NRC DOCKETS: 50-373 and 50-374

RESPONSES TO NRC COMMENTS
MAIN STEAMLINE ISOLATION VALVE (MSIV)
LEAKAGE CONTROL SYSTEM (LCS)
ALTERNATE LEAKAGE TREATMENT (ALT) PATH

1. TURBINE BUILDING ROOF STRUCTURE

Turbine Bldg. Portion
of
Vertical Seismic Model
Ref. (Seismic Response Spectra
Design Criteria DC-SE-02-LS, Rev. 0)

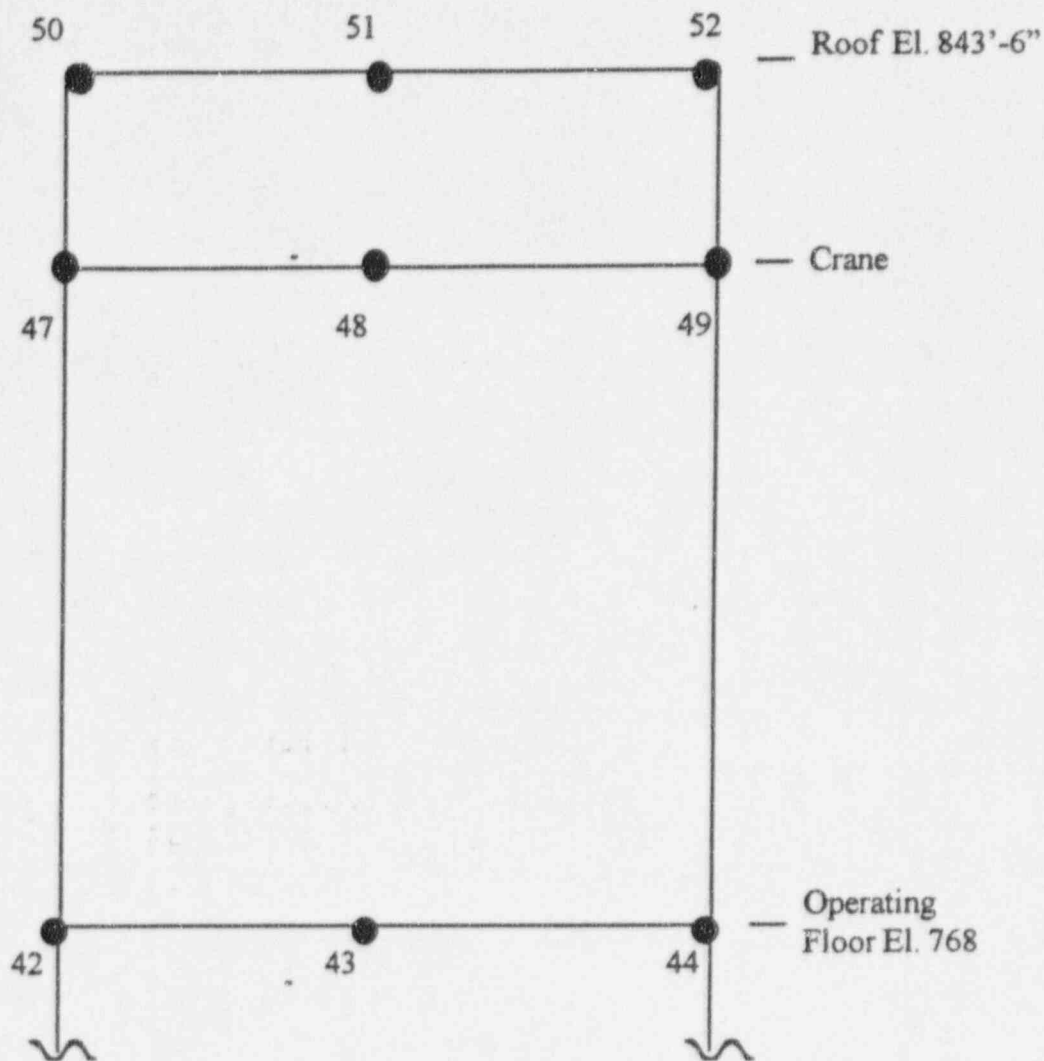
A sketch of the vertical seismic model is shown on Attachment 1-1. The vertical members shown on this sketch represent Column Rows R and W. Node 51 of this model represents the vertical response of the structure at the roof level and is the basis for Spectra 126-DB-VS (Attachment 1-2). The horizontal members connecting node 51 to nodes 50 and 52 were modeled rigid. Since the frequency of the roof with the girder stiffness is approximately 2.4 hz (Attachment 1-3), the inertial forces from the roof at 2.4 hz will be approximately 0.32g using Spectra 126-DB-VS.

Attachment 1-2
Page 1 of 1

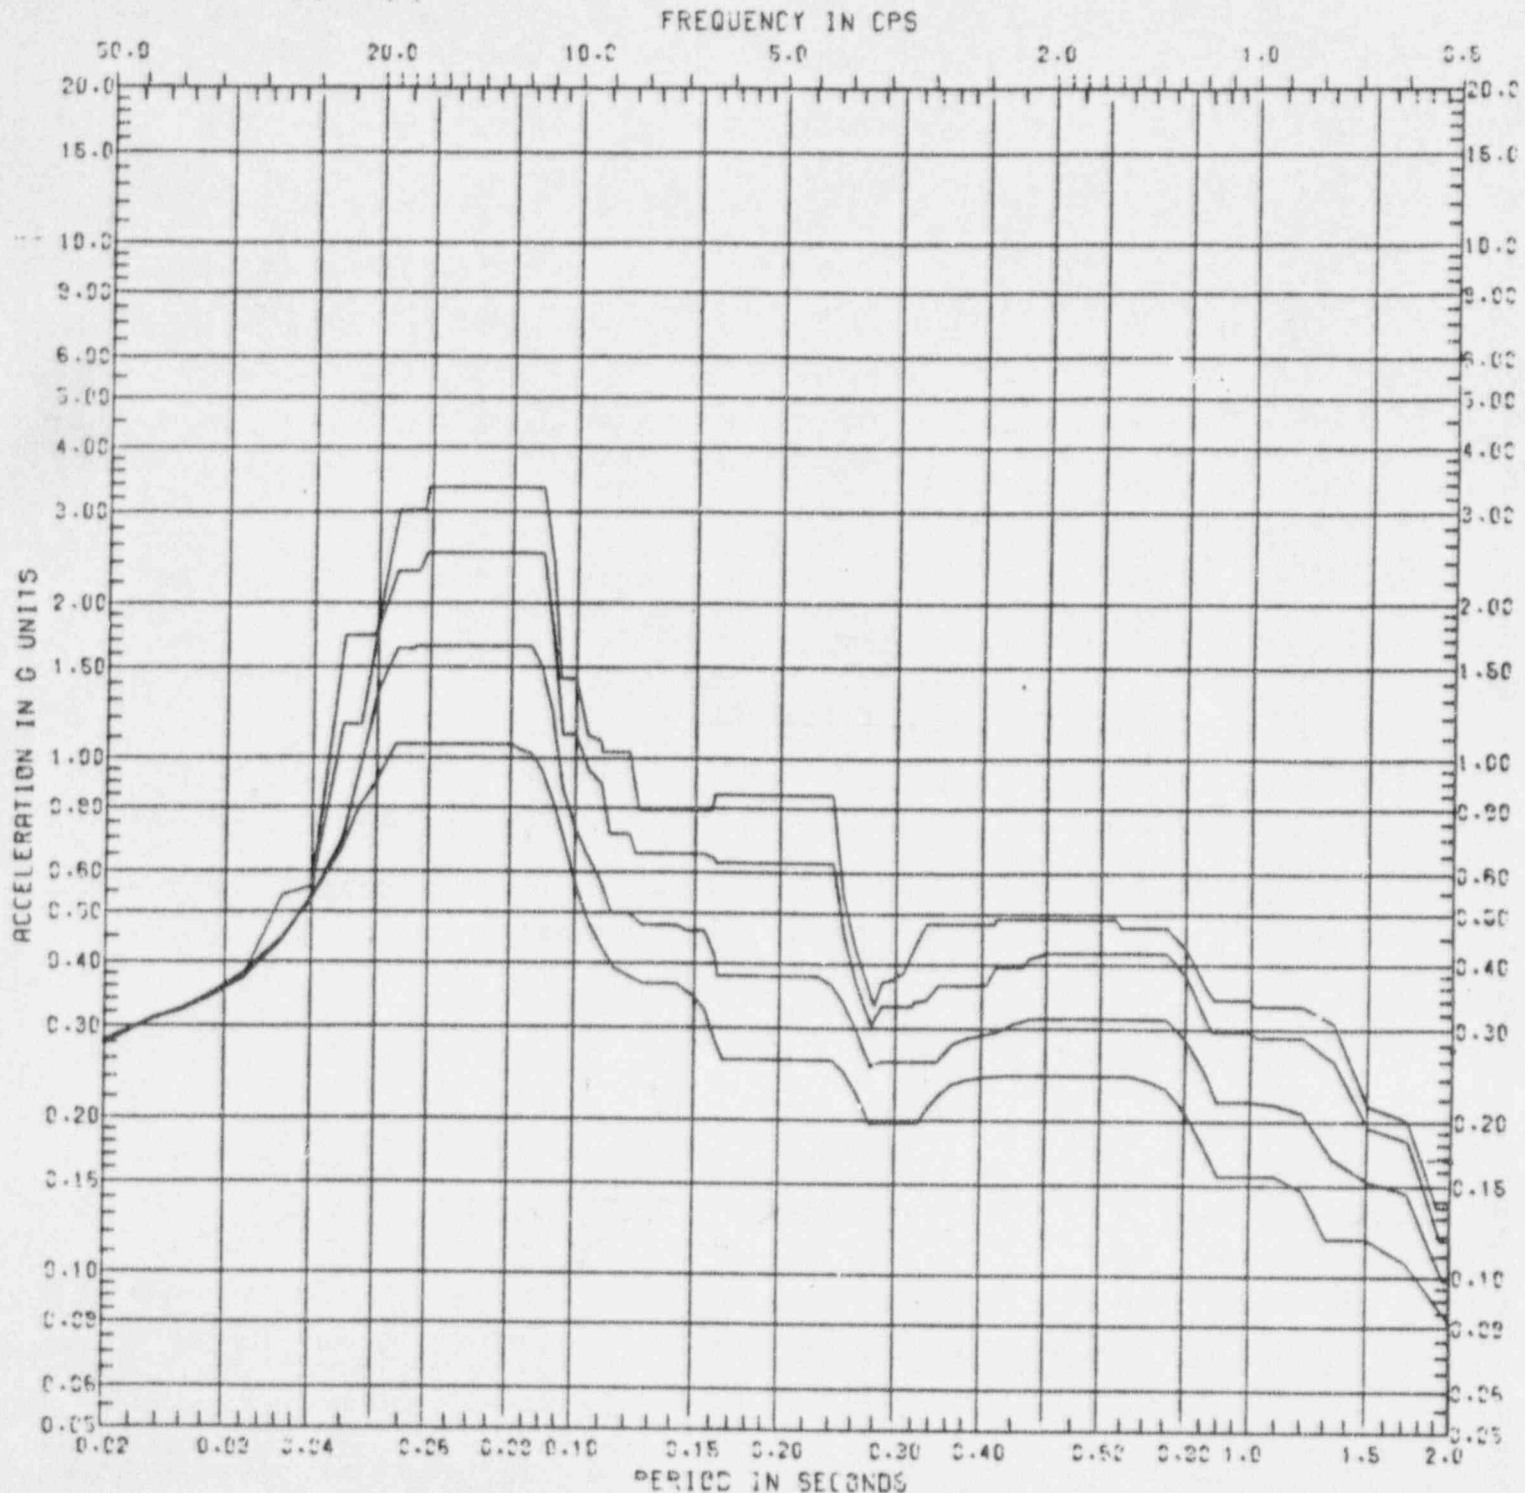
The finite element model that was created to confirm the horizontal behavior of the roof, as described below, was also used to verify the vertical behavior of the roof. Spectra 126-DB-VS is used as input to the response spectra analysis. The vertical inertial force from the roof panel is 123 kips based on 466 kips seismic weight; therefore, this detailed evaluation resulted in an equivalent acceleration value of 0.27g (123/466) which compares to the 0.32g extracted from the response spectra. In the vertical direction, since the increase in allowable for SSE and normal loads for flexure is 1.6, the design margin in the vertical direction is 1.21 ($=1.6/1.32$) based on Updated Final Safety Analysis Report (UFSAR) allowables.
